Authors' response to Reviewer 1

Comment from Referee: In this study, a high-resolution surface-unsaturated_zone-aquifer flow model was fit to a km² scale hilly drainage basin near Los Angeles, to investigate spatial and temporal variability of groundwater recharge. The main result is that, although the long-term spatial average recharge under the catchment is 16 mm/yr, under the small alluvial valley after heavy rain, focused temporal recharge rate may reach 1000 mm/yr.

Figure 1. Schematic diagram for Mountain block and Mountain Front Recharge (Figure 2 from Wilson and Guan, 2004). The red circle represents the location of the catchment in this study.

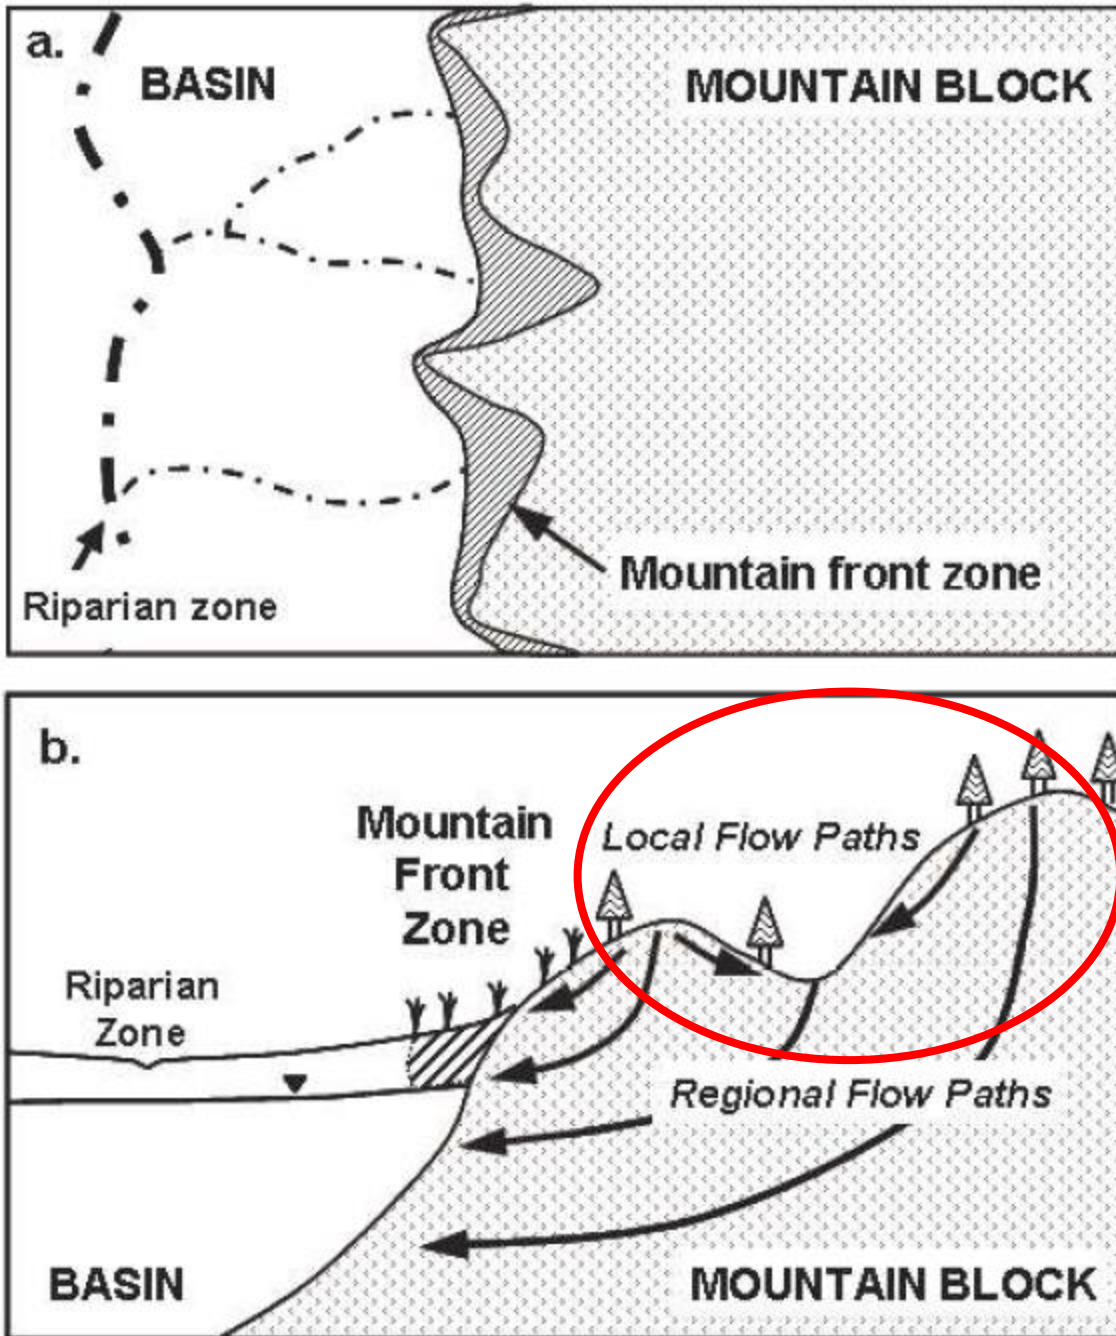
2) Comment from Referee: Concerning the discussion above: I would say that the recharge characteristics described in the manuscript is similar to what many studies term: Mountain Front Recharge (MFR). Aquifers under alluvial valleys in mountainous regions are recharged from the edge of the valley (mountain front) or maybe altogether in subsurface recharge of rain percolating in the mountain block (can explain fresh groundwater above saline unsaturated zone). Discuss your findings in light of MFR literature.

Author's response: We thank you the reviewer for this suggestion that allows us to describe better our conceptual model and the hydrologic processes involved. The spatial distribution of recharge and the proposed conceptual model might recall what has been defined Mountain Front Recharge (Wilson and Guan, 2004). However, the catchment is located on an upland ridge that represents, on a regional scale, the mountain block. Although the processes observed are similar to those described as diffuse and focused MFR (direct water-table recharge at the edge of a slope front), we believe that recharge characteristics are more similar to recharge at the mountain block. A classic MFR and MBR approach would have been possible including the surrounding Simi and San Fernando valleys (about 300 m below the studied catchment). Instead, we only focused on a small watershed (2.16 km²), with a local relief of 150 m located on the top of the Simi Hills. The maximum thickness of the alluvium overlying the sandstone bedrock in the low areas of the catchment, where the majority of recharge occurs, is only 3.8 m and therefore this setting is different from the alluvial-filled basins described in several Mountain Front recharge papers (Aishlin and McNamara, 2011; Carling et al., 2012; Manning and Solomon, 2003; Bresciani et al., 2018). Given all these considerations, we believe that the system represents a small portion of the Mountain block rather than the MFR (see Figure 1 at the end of the document)
